SUPPLEMENT NO. 1

PHILIP R SMITH ELEMENTARY SCHOOL
GILBANE JOB NO. J07896.000
STATE PROJECT NO. 132-0089N

PRS-SI-0007

Owner Room Names and Signage

A1.1

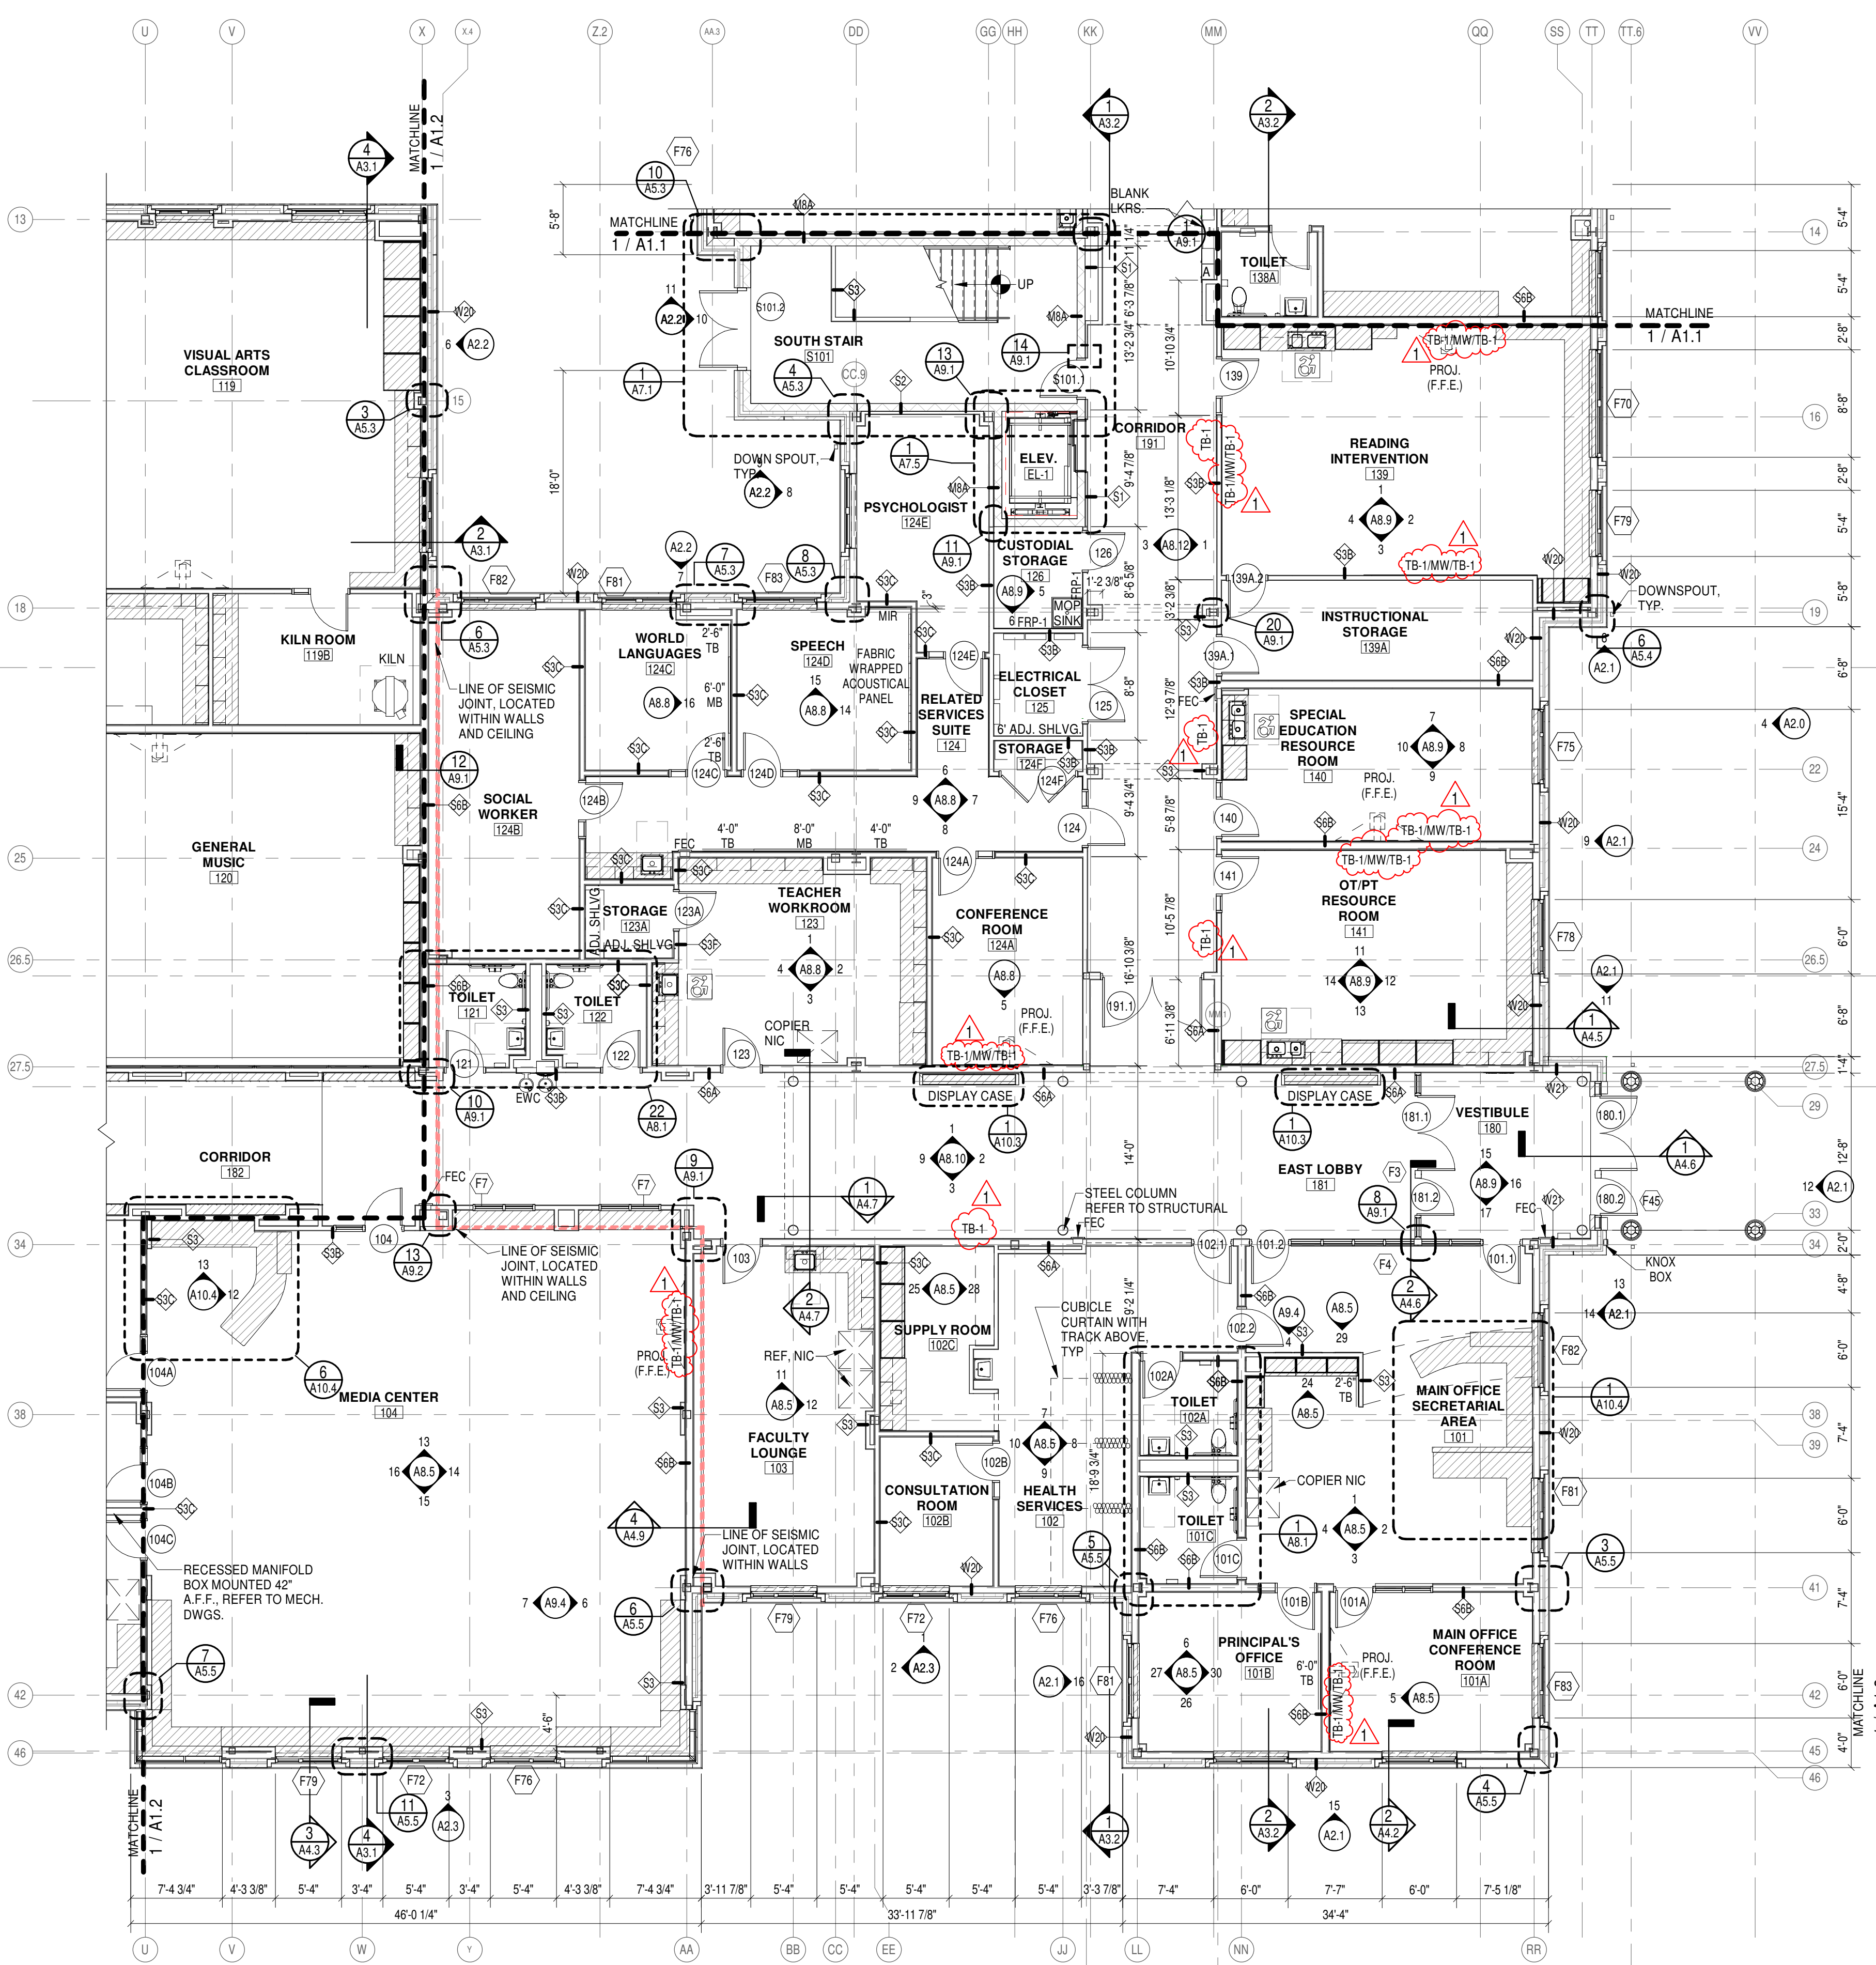
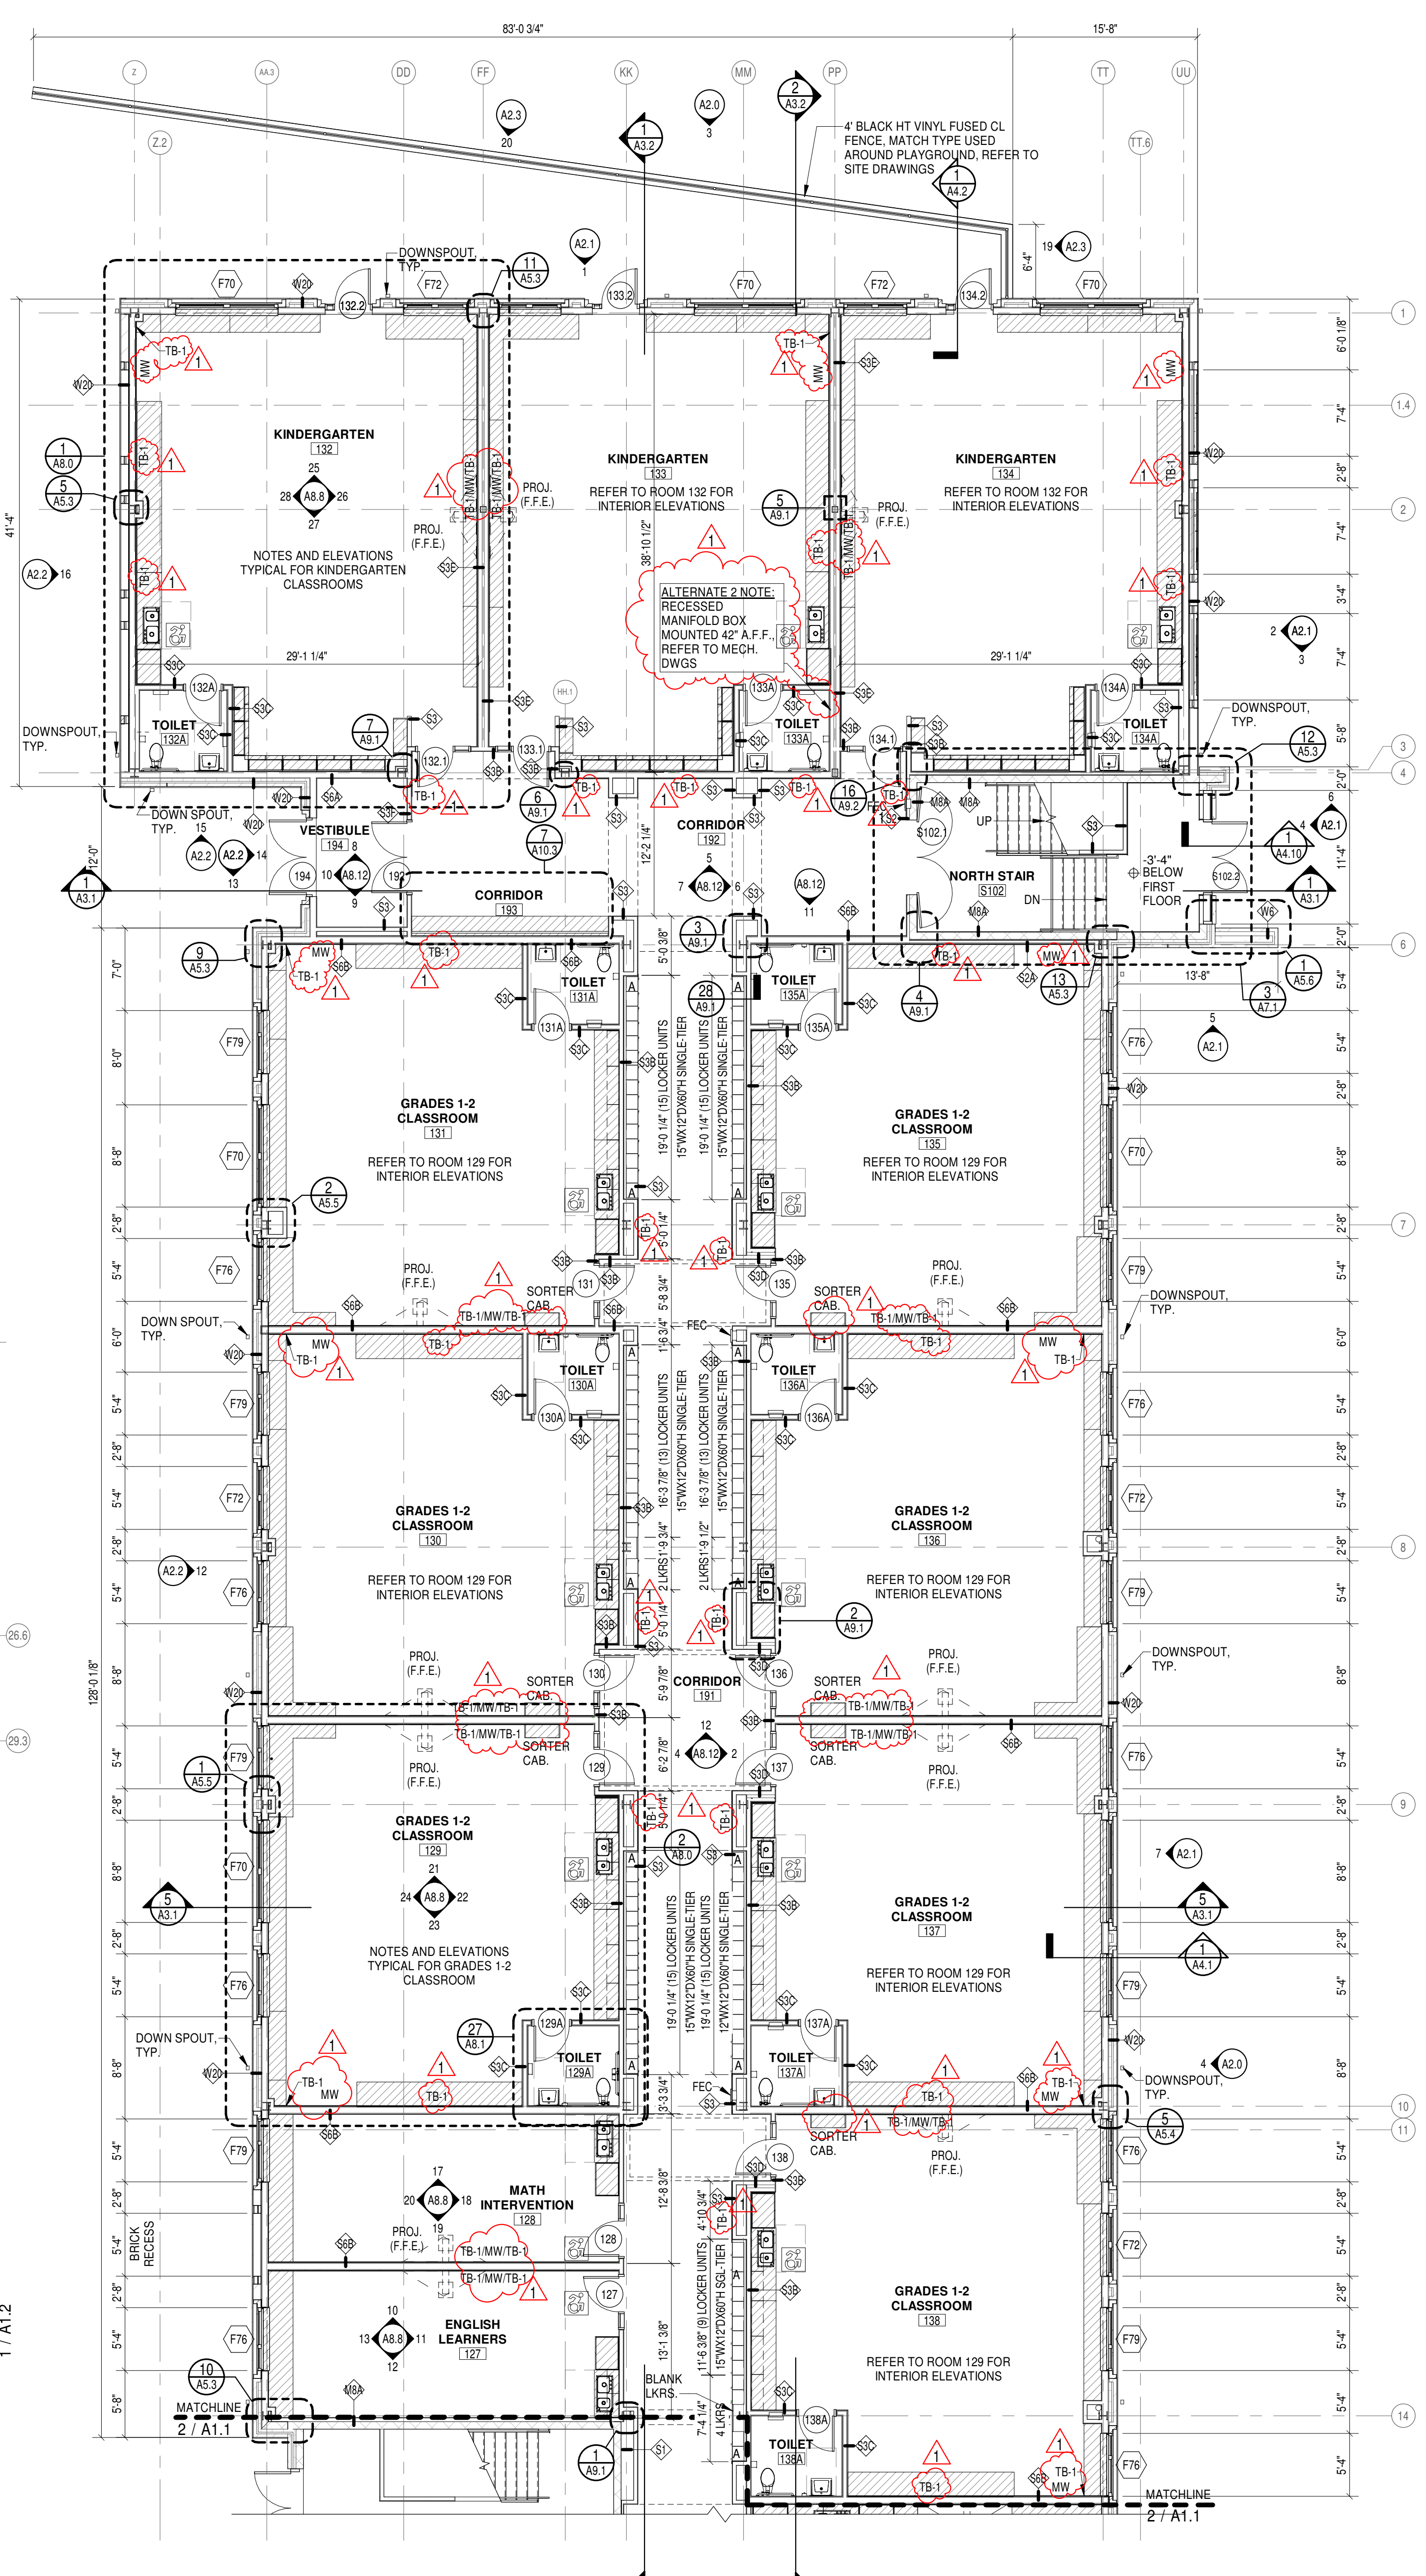
DRAWING A1.1 - PARTIAL FIRST FLOOR CONSTRUCTION PLAN - NORTH AND WEST: **REMOVE** drawing as Issued for Bids and **REPLACE** with drawing attached to this Addendum with the following revisions:
